Contract #: 04-0120F4
Cty: SF/ALA Rte: 80 PM: 13.2/13.9
File #: 69.25B

QUALITY ASSURANCE -- NON-CONFORMANCE REPORT

Location: Changxing Island, Shanghai, P.R. China **Report No:** NCR-000583
Prime Contractor: American Bridge/Fluor Enterprises, a JV **Date:** 02-Jan-2010
Submitting Contractor: Zhenhua Port Machinery Company, Ltd (ZPMC), Changxing Island **NCR #:** ZPMC-0556

Reference Description: Missed MT transverse indication by QC for Bike Path Cantilever Beam BK001-032

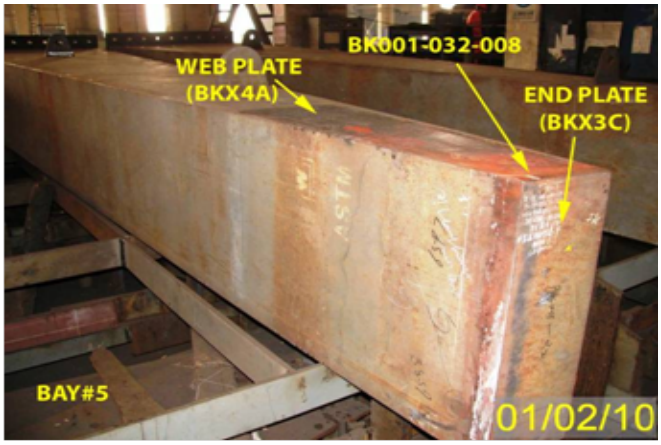
During Magnetic Particle Testing (MT) review of welds on Bike Path Cantilever Beams, this Quality Assurance Inspector (QA) discovered the following issues:

-One (1) transverse linear indication measuring approximately 8mm in length.
-The member is identified as Bike Path Cantilever Beam BK001-032.
-The weld is identified as BK001-032-008.
-The weld is a Partial Joint Penetration (PJP) T-joint joining the Web Plate (BKX4A) to the Diaphragm Flange Plate (BKX3C).
-The member is Non-Seismic Performance critical Member (SPCM).
-The member is located in OBG Bay 5.

The Notice of Witness Inspection Number (NWIT) is 004981. The indication is located inside the area that has been previously tested and accepted by ZPMC Quality Control (QC) personnel. As per the contract documents, ZPMC's QC personnel are required to perform 100% MT inspection of this weld.

Propose a resolution for the identified non-conformance with revised procedures to prevent future occurrences. Provide training and equipment as required to the ZPMC MT technician to ensure these types of indications are identified in the future. A response for the resolution of this issue is expected within 7 days.

ZPMC	关键焊缝返修报告 Critical Welding Repair Report (CWR)				版本 Rev. No
项目名称 Project Name:	美国海湾大桥 SFOBB	部件图号 Drawing No.:	BK1	报告编号 Report No.:	0 B-CWR102
合同号 Contract No.:	04-0120F4	部件名称 Item Name:	OBG CANTILEVER BOX BRACKET	NDT 报告编号 NDT Report No.:	B787-MT-174
项目编号 Project No.:	ZP06-787

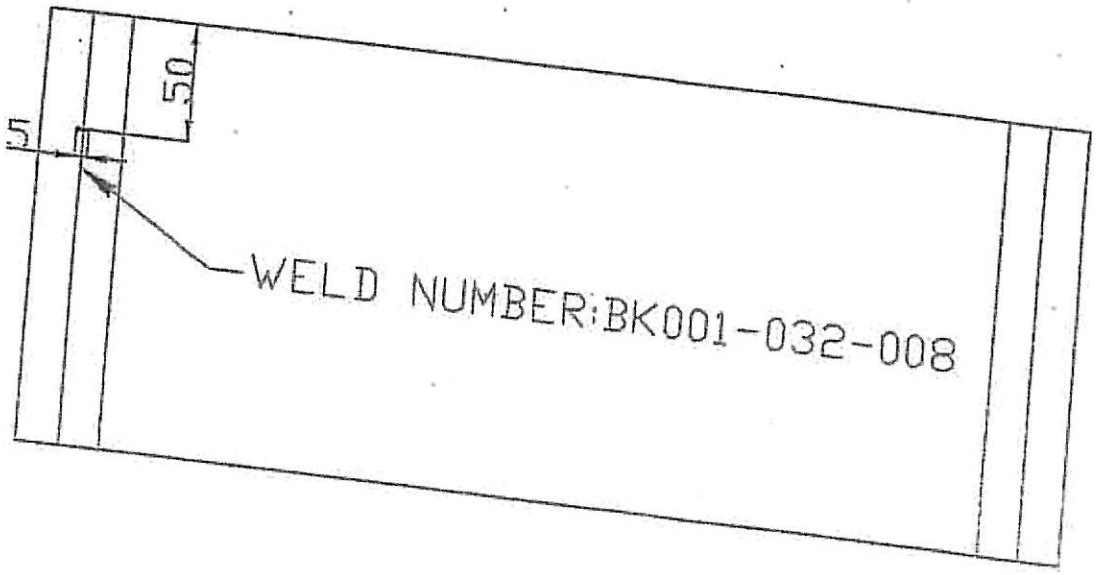
Draft of Welding Discontinuity:

2. QC and a Lead CWI shall have an approved copy of the CWR in hand prior to the repair.
3. Remove paint≥25mm in all direction of HAZ prior to MT.
4. Clean the excavation area of all loose debris including MT powder. Preheat to 65° C before removing cracks by grinding, repair area shall extend a minimum of 50mm beyond each end of single crack repairs.

6. Prepare excavation in accordance with the New Repair Procedure prior to welding.
7. Before this repair, Verify with VT and MT repair areas are defects free, and also MT shall be performed on the base metal laying abroad cracks to ensure that no cracks were propagated to the base metal. Separate CWR approval is needed if cracks are found in the base metal, and only after this new CWR's approval can continue the repair.

WELD NUMBER: CB202A-016-002

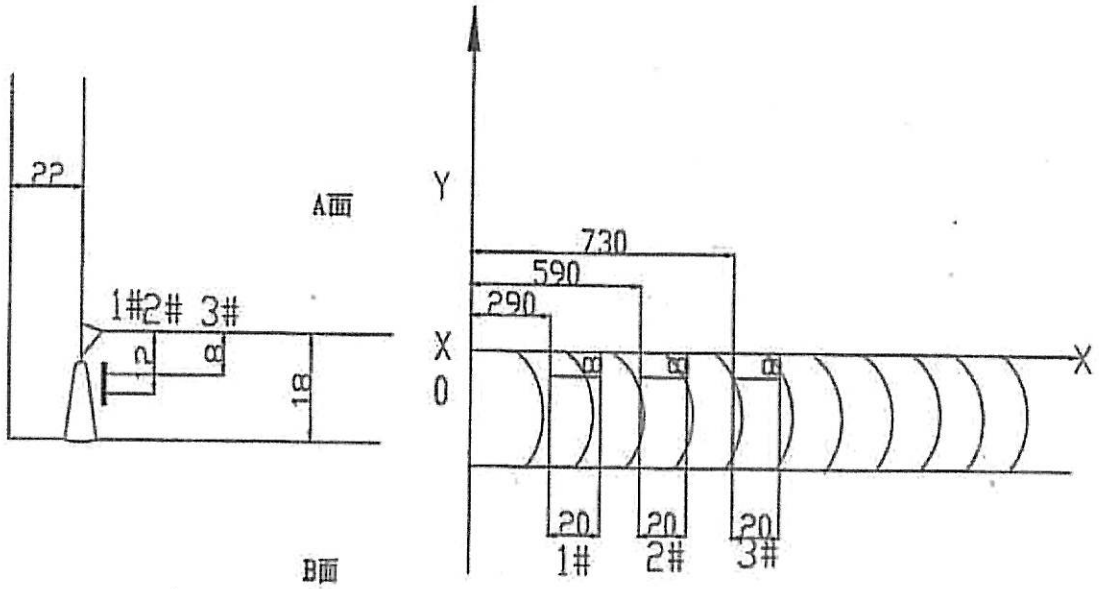
Draft of welding discontinuity:

1. Gouge or grind from nearer side from metal edge （D≤0.65T, "D" is depth of defects, "T" is thickness of metal） to remove all defects;
2. Follow repair WPS for joint preparation, preheat, and weld deposit;
3. Verify with VT no defects remain in the weld joint prior to welding;
4. Grind the repaired area flush with base metal or the adjacent weld;
5. Check the welds according to the working drawings;

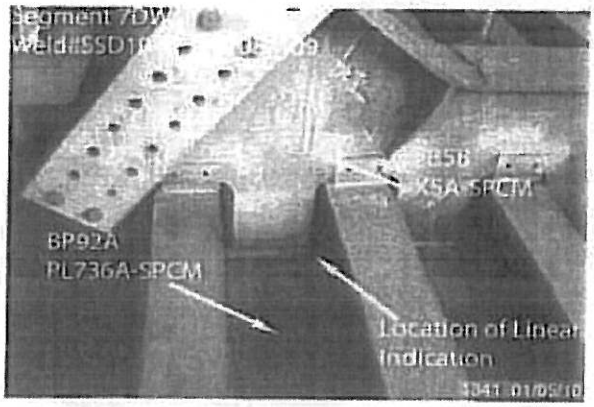
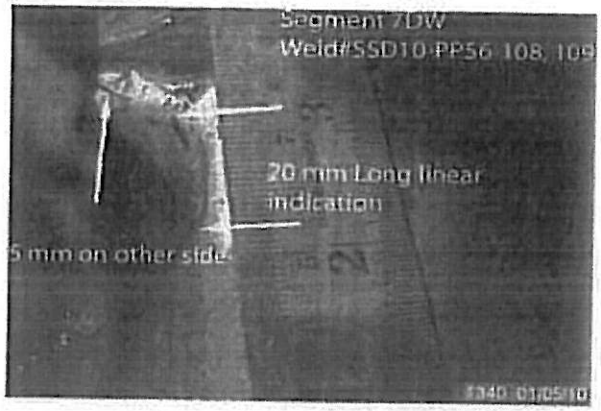
-One (1) Longitudinal linear indication measuring approximately 20mm in length.
-The welds are identified as: SSD10-PP56-108, 109.
-These welds are a Fillet Weld type joining the Bottom Plate (BP92A) to Floor Beam (FB5B) web plate.
-These welds are designated as Seismic Performance Critical Member (SPCM) on the approved drawing (SEGSD10).
-The OBG segment 7DW is located outside in the Trial Assembly area.

The Notice of Witness Inspection Number (NWIT) is 004993. The indication is located inside the area that has been previously tested and accepted by ZPMC Quality Control (QC) personnel. ZPMC's QC personnel are required to perform twenty five (25%) percent MT inspection of this weld.

Propose a resolution for the identified non-conformance with revised procedures to prevent future occurrences. Provide the training and equipment required for the ZPMC MT technician such that these indications are found. A response for the resolution of this issue is expected within 7 days.

ZPMC	关键焊缝返修报告 Critical Welding Repair Report (CWR)				版本 Rev. No.: 0
项目名称 Project Name:	美国海湾大桥 SFOBB	部件图号 Drawing No.:	SSD10	报告编号 Report No.:	B-CWR1043
合同号 Contract No.:	04-0120F4	部件名称 Item Name:	OBG FLOOR BEAM AND BOTTOM PLATE	NDT 报告编号 NDT Report No.:	B787-MT-17605
项目编号 Project No.:	ZP06-787

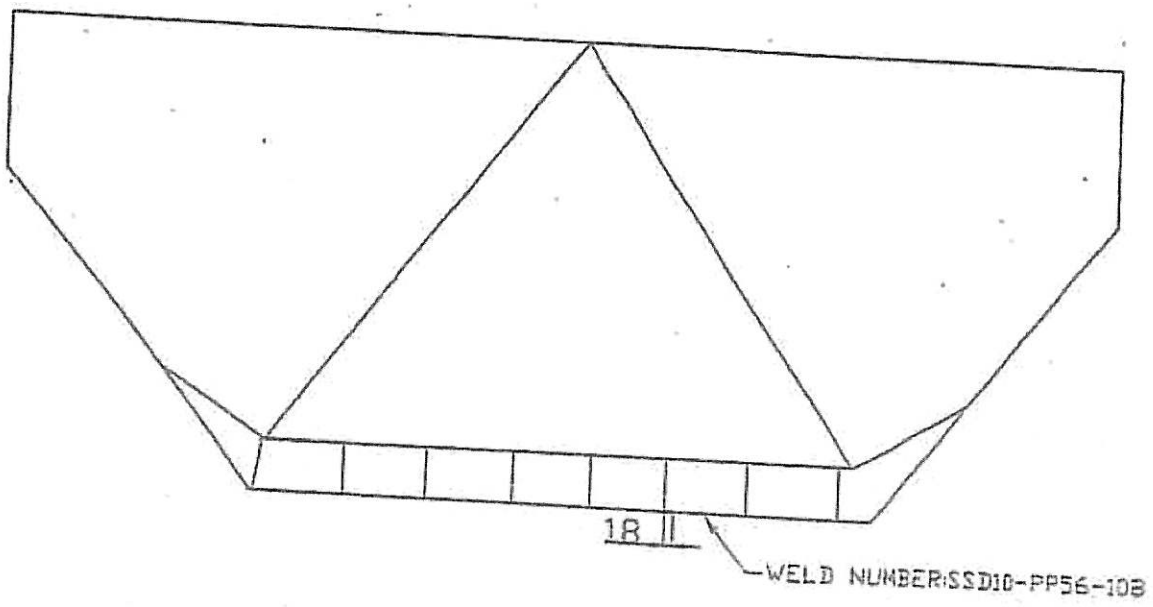
Draft of Welding Discontinuity:

2. QC and a Lead CWI shall have an approved copy of the CWR in hand prior to the repair.
3. Remove paint≥25mm in all direction of HAZ prior to MT.
4. Clean the excavation area of all loose debris including MT powder. Preheat to 65° C before removing cracks by grinding, repair area shall extend a minimum of 50mm beyond each end of single crack repairs.

6. Prepare excavation in accordance with the New Repair Procedure prior to welding.
7. Before this repair, Verify with VT and MT repair areas are defects free, and also MT shall be performed on the base metal laying abroad cracks to ensure that no cracks were propagated to the base metal. Separate CWR approval is needed if cracks are found in the base metal, and only after this new CWR's approval can continue the repair.

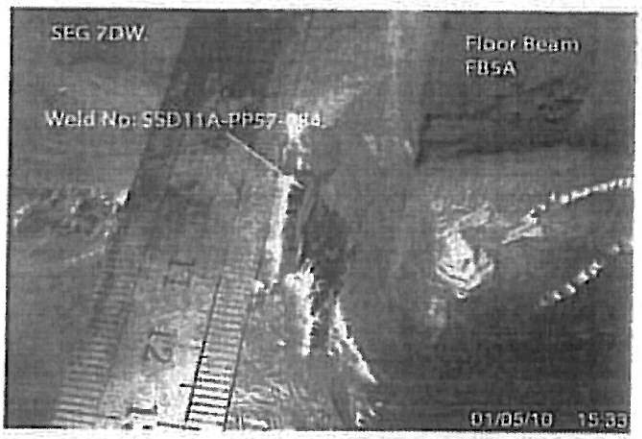
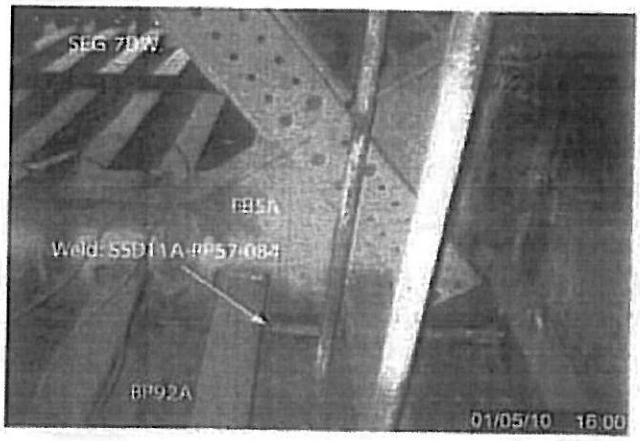
-The approved shop drawings, detail this weld as a Fracture Critical Weld (FCW).

-Segment 7DW is located at outside yard, north end of bays 13 and 14.

The Notice of Witness Inspection Number (NWIT) is 004993. The indication is located within the area that has been previously tested and accepted by ZPMC Quality Control (QC) personnel. ZPMC's QC personnel are required to perform twenty five (25%) percent MT inspection of this weld.

Propose a resolution for the identified non-conformance with revised procedures to prevent future occurrences. Provide the required training and equipment to the ZPMC MT technician such that indications such as this are found. A response for the resolution of this issue is expected within 7 days.

ZPMC	关键焊缝返修报告 Critical Welding Repair Report (CWR)				版本 Rev. No.: 0
项目名称 Project Name:	美国海湾大桥 SFOBB	部件图号 Drawing No.:	SSD11	报告编号 Report No.:	B-CWR1044
合同号 Contract No.:	04-0120F4	部件名称 Item Name:	OBG FLOOR BEAM AND BOTTOM PLATE 7DW	NDT 报告编号 NDT Report No.:	B787-MT-1760
项目编号 Project No.:	ZP06-787

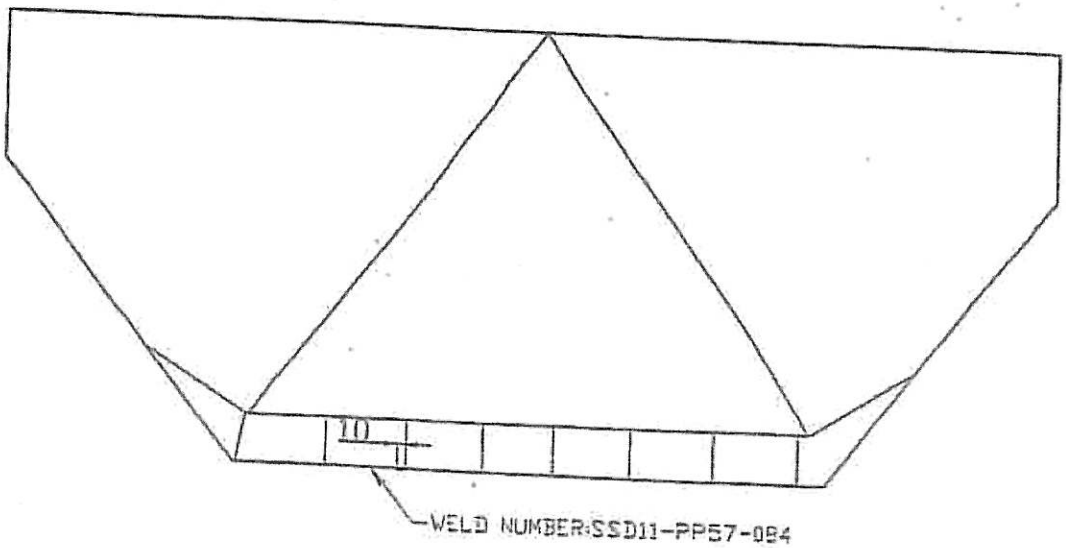
Draft of Welding Discontinuity:

2. QC and a Lead CWI shall have an approved copy of the CWR in hand prior to the repair.
3. Remove paint≥25mm in all direction of HAZ prior to MT.
4. Clean the excavation area of all loose debris including MT powder. Preheat to 65° C before removing cracks by grinding, repair area shall extend a minimum of 50mm beyond each end of single crack repairs.

6. Prepare excavation in accordance with the New Repair Procedure prior to welding.
7. Before this repair, Verify with VT and MT repair areas are defects free, and also MT shall be performed on the base metal laying abroad cracks to ensure that no cracks were propagated to the base metal. Separate CWR approval is needed if cracks are found in the base metal, and only after this new CWR's approval can continue the repair.

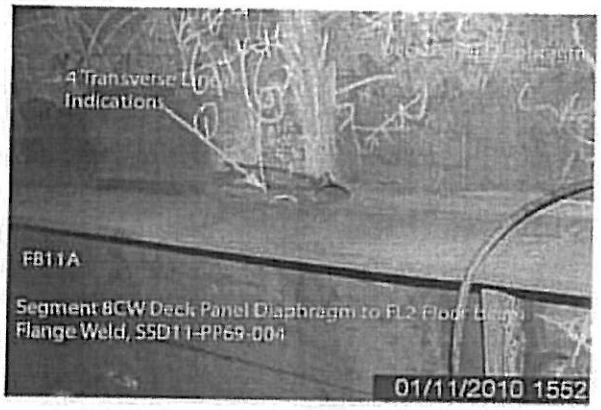
-The Notice of Witness Inspection Number (NWIT) is 005037.

-The indication is located in an area that has been previously tested and accepted by ZPMC Quality Control (QC) personnel. According to the contract documents ZPMC Quality Control (QC) is required to perform 100% Magnetic particle Testing (MT) of this weld.

Propose a resolution for the identified non-conformance with revised procedures to prevent future occurrences. Provide the required training and equipment to the ZPMC MT technician in order to recognize these sorts of indications. A response for the resolution of this issue is expected within 7 days.

ZPMC	关键焊缝返修报告 Critical Welding Repair Report (CWR)				版本 Rev. N 0
项目名称 Project Name:	美国海湾大桥 SFOBB	部件图号 Drawing No.:	SSD11	报告编号 Report No.:	B-CWR1
合同号 Contract No.:	04-0120F4	部件名称 Item Name:	8CW FLOOR BEAM SPLICE	NDT 报告编号 NDT Report No.:	B787-MT-1
项目编号 Project No.:	ZP06-787

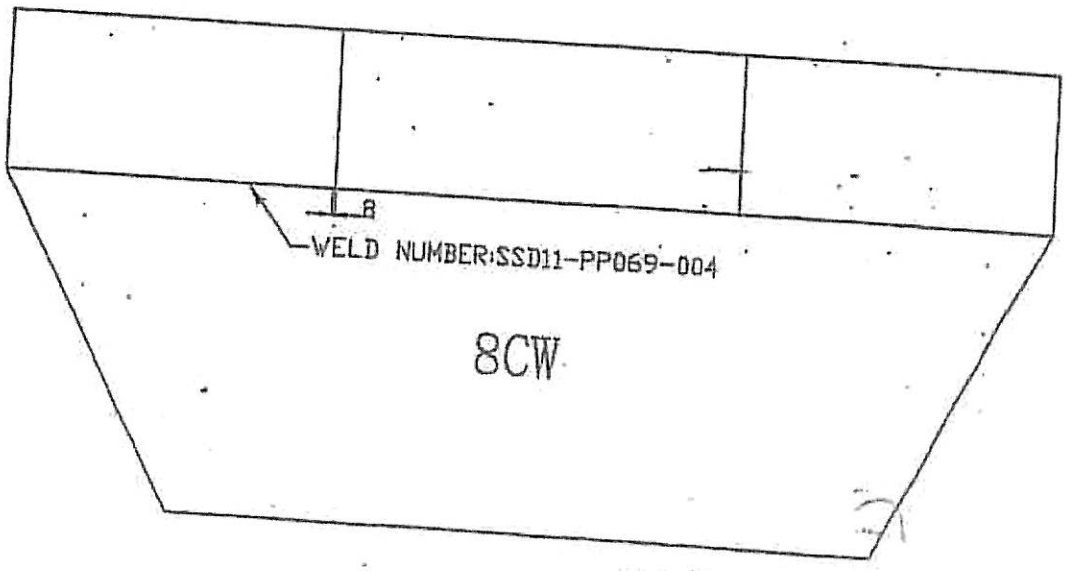
Draft of Welding Discontinuity:

2. QC and a Lead CWI shall have an approved copy of the CWR in hand prior to the repair.
3. Remove paint≥25mm in all direction of HAZ prior to MT.
4. Clean the excavation area of all loose debris including MT powder. Preheat to 65° C before removing cracks by grinding, repair area shall extend a minimum of 50mm beyond each end of single crack repairs.

6. Prepare excavation in accordance with the New Repair Procedure prior to welding.
7. Before this repair, Verify with VT and MT repair areas are defects free, and also MT shall be performed on the base metal laying abroad cracks to ensure that no cracks were propagated to the base metal. Separate CWR approval is needed if cracks are found in the base metal, and only after this new CWR's approval can continue the repair.

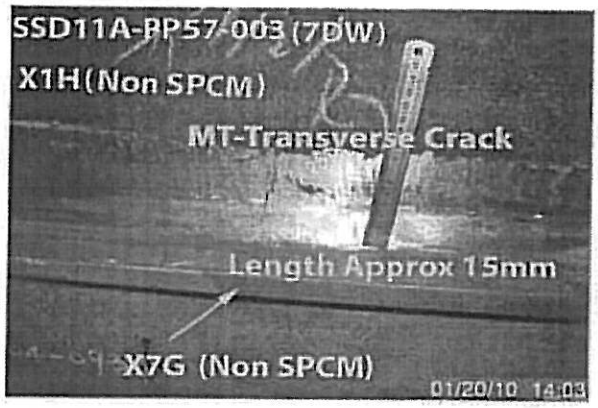
-One (1) Transverse linear crack measuring approximately 15mm in length.
-The Y location is 4500mm from corner of the Panel Point PP57 at Cross Beam side.
-The indication is clearly marked on the material near the weld.
-The weld is identified as: SSD11A-PP57-003.
-This weld is a Complete Joint Penetration (CJP) weld joining the Deck Panel Diaphragm (X1H) to Floor Beam Flange (X7G).
-The Deck Panel Diaphragm (X1H) is identified as Non-Seismic Performance Critical Member (SPCM).
-The Floor Beam Flange (X7G) is identified as Non-SPCM.
-OBG segment 7DW is located outside North side of Bay 13.

The Notice of Witness Inspection Number (NWIT) is 005086. The indication is located inside an area that has been previously tested 100% and accepted by ZPMC Quality Control (QC) personnel.

Propose a resolution for the identified recurring non-conformance which constitutes a systematic problem on both materials/workmanship and quality control issues with revised procedures to remedy the defected work and to prevent future occurrences. A response for the resolution of this issue is expected within 14 days.

ZPMC	关键焊缝返修报告 Critical Welding Repair Report (CWR)				版本 Rev. No.: 0
项目名称 Project Name:	美国海湾大桥 SFOBB	部件图号 Drawing No.:	SEG039	报告编号 Report No.:	B-CWR1167
合同号 Contract No.:	04-0120F4	部件名称 Item Name:	OBG DECK PLATE SPLICE 7DW	NDT 报告编号 NDT Report No.:	B787-MT-18475
项目编号 Project No.:	ZP06-787

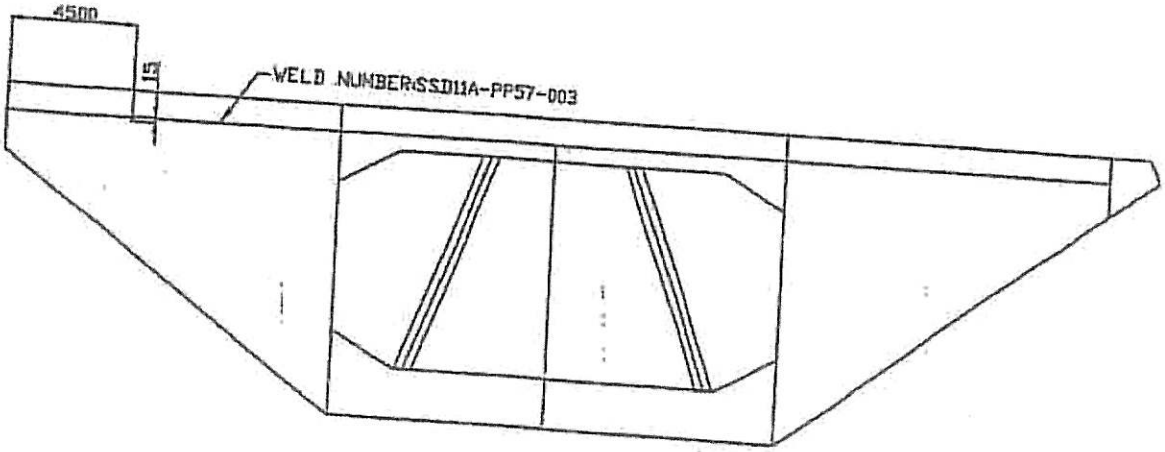
Draft of Welding Discontinuity:

3. Remove paint≥25mm in all direction of HAZ prior to MT.

7. Before this repair, Verify with VT and MT repair areas are defects free, and also MT shall be performed on the base metal laying abroad cracks to ensure that no cracks were propagated to the base metal. Separate CWR approval is needed if cracks are found in the base metal, and only after this new CWR's approval can continue the repair.

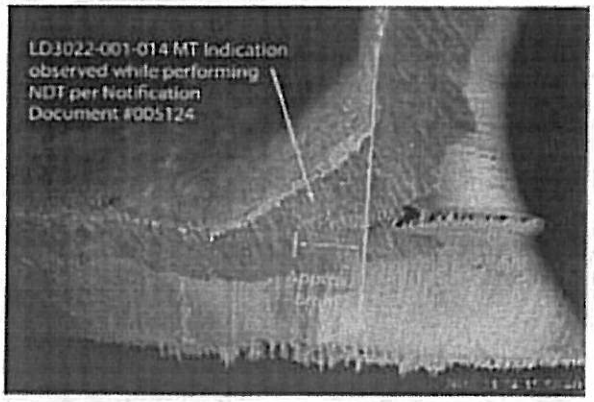
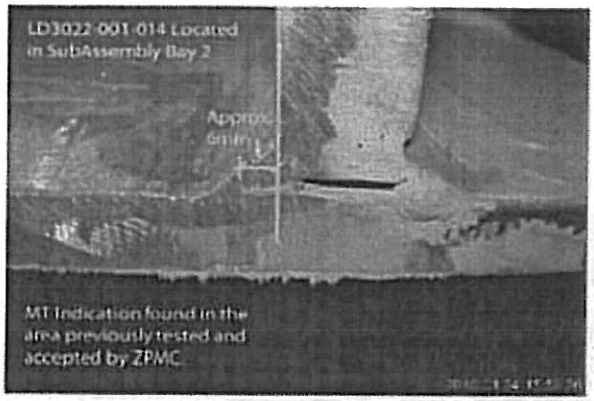
During the Quality Assurance Magnetic Particle Testing (MT) review of welds located on LD3022-001, this Quality Assurance Inspector (QA) discovered the following issues:

-One (1) linear indication measuring approximately 6mm in length.
-The weld is identified as: LD3022-001-014 for Lift 12.
-The area was previously repaired by ZPMC using Critical Weld Repair (CWR) 1151.
-The fillet weld size is 12mm.
-This Fillet Weld joins longitudinal diaphragm stiffener to longitudinal diaphragm web plate.
-This weld is designated as Non-Seismic Performance Critical Member.
-The Notice of Witness Inspection Number (NWIT) is 005124. The indication is located inside the area that has been previously tested and accepted by ZPMC Quality Control (QC) personnel. ZPMC Quality Control (QC) has performed 100% Magnetic particle Testing (MT) of this weld.

Propose a resolution for the identified recurring non-conformance which constitutes a systematic problem on both materials/workmanship and quality control issues with revised procedures to remedy the defected work and to prevent future occurrences. A response for the resolution of this issue is expected within 14 days.

ZPMC	关键焊缝返修报告 Critical Welding Repair Report (CWR)				版本 Rev. No.: 0
项目名称 Project Name:	美国海湾大桥 SFOBB	部件图号 Drawing No.:	LD3022	报告编号 Report No.:	B-CWR1151
合同号 Contract No.:	04-0120F4	部件名称 Item Name:	12th lifting longitudinal diaphragm	NDT 报告编号 NDT Report No.:	B787-MT-17930
项目编号 Project No.:	ZP06-787

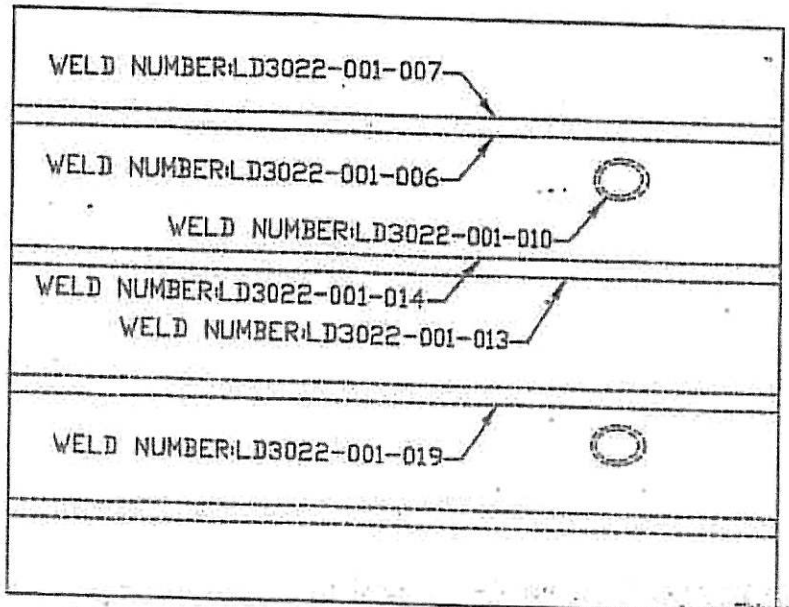
Draft of Welding Discontinuity:

2. QC and a Lead CWI shall have an approved copy of the CWR in hand prior to the repair.
3. Remove paint≥25mm in all direction of HAZ prior to MT.
4. Clean the excavation area of all loose debris including MT powder. Preheat to 65° C before removing cracks by grinding, repair area shall extend a minimum of 50mm beyond each end of single crack repairs. and 50m m beyond the outermost cracks for multiple crack repairs

6. Prepare excavation in accordance with the New Repair Procedure prior to welding.
7. Before this repair, Verify with VT and MT repair areas are defects free, and also MT shall be performed on the base metal laying abroad cracks to ensure that no cracks were propagated to the base metal. Separate CWR approval is needed if cracks are found in the base metal, and only after this new CWR's approval can continue the repair.
